**ADDENDUM NO. 01**

**OWNER:** Reclamation District No. 108

**PROJECT:** Operations Building

SHEET NO.  
**A-2.3**

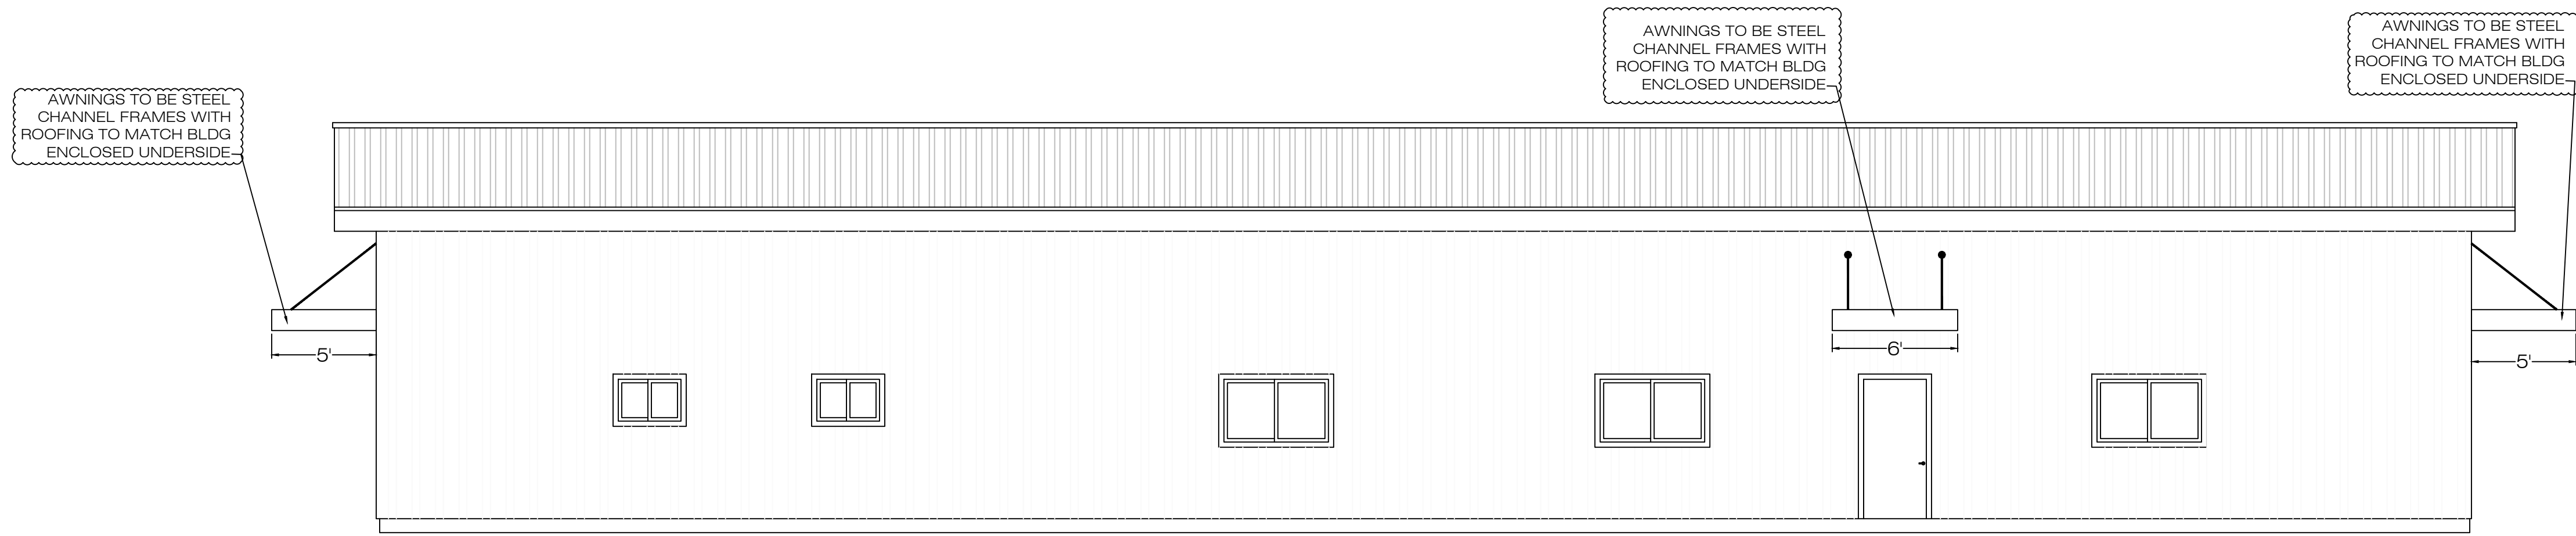
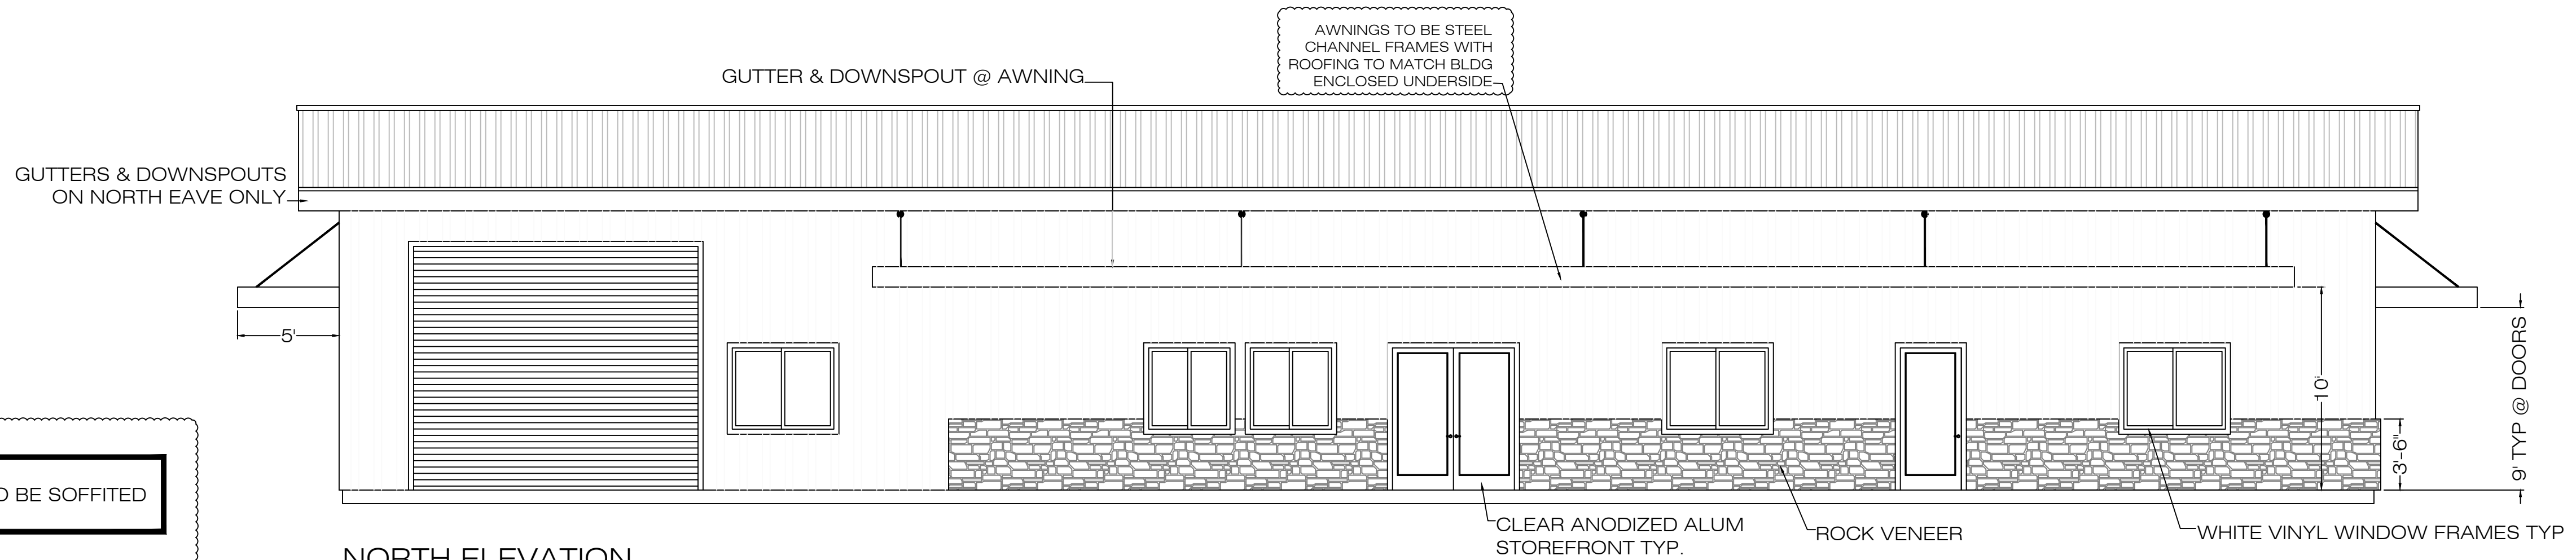
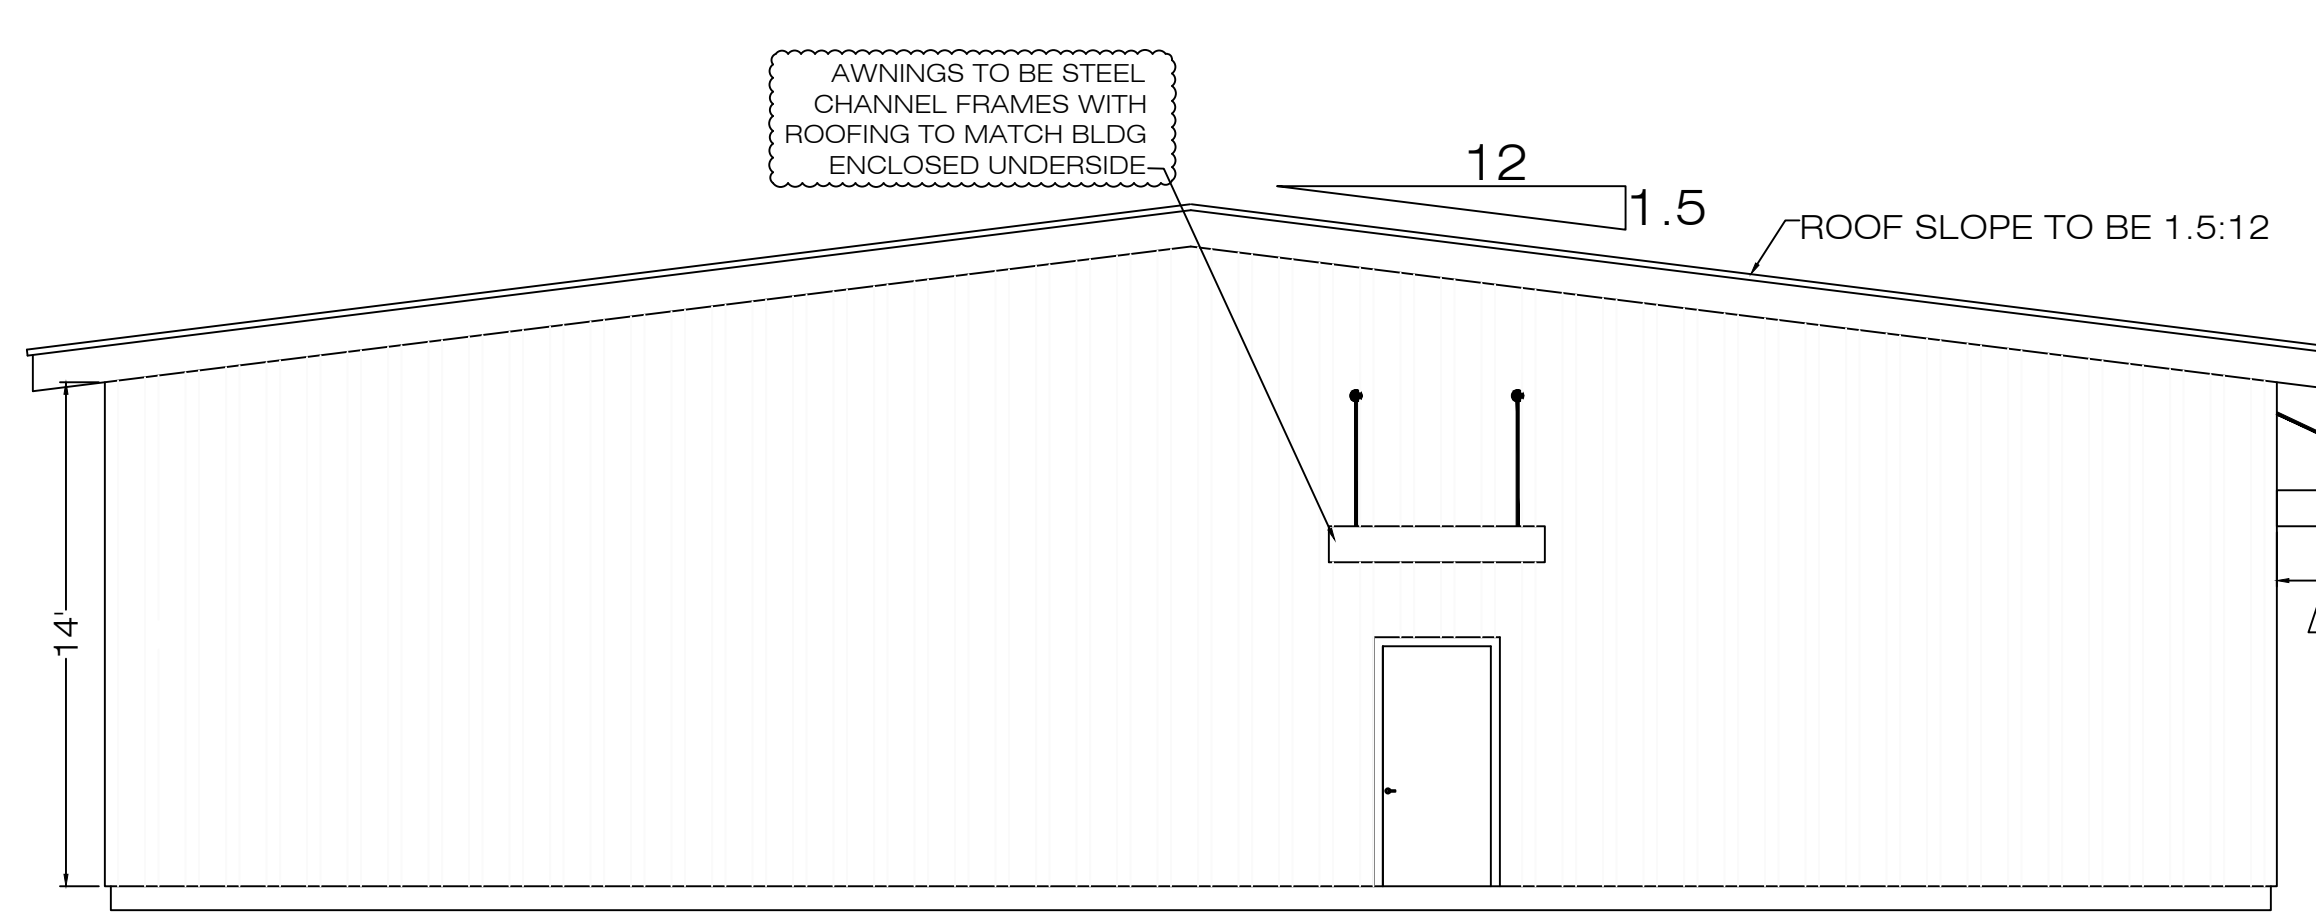
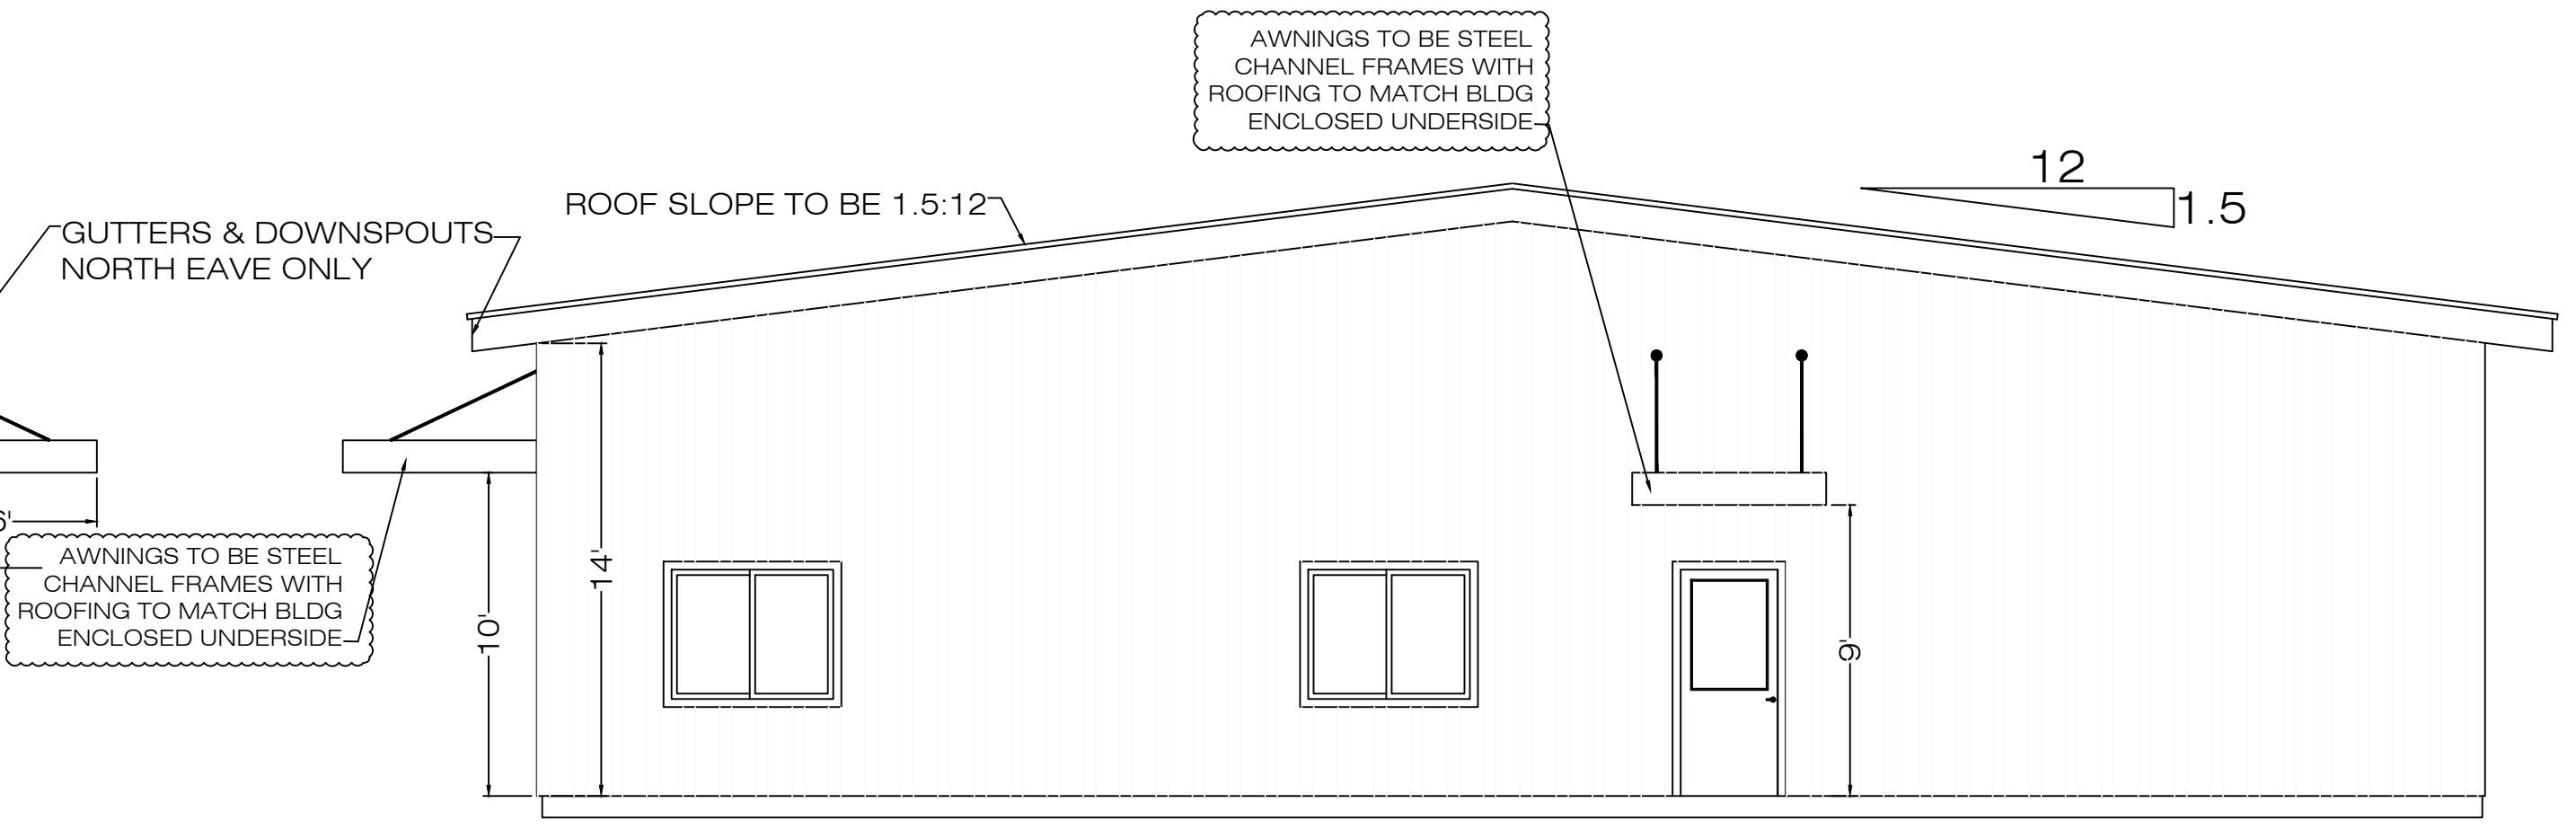
Q: Will the overhangs need to be soffitted?

Q: Will the awning need to be soffitted?

- A. **No colored concrete in this phase. Specifications revised accordingly**
- Q. May we instead provide Milgard Trinsic or Tuscan Vinyl windows, to eliminate moisture sweat through the specified aluminum framed windows?

A: **Yes. See revised plans.**

A: **Yes. See revised plans.**

- A. **Assume white vinyl windows per the exterior elevation design shown on the plans.**
- Q. Is there a spec on the Man-Doors? Knock-down vs pre-assembled, self-closing, kick-plates, etc?

\*ALL EAVES ARE TO BE SOFFITED
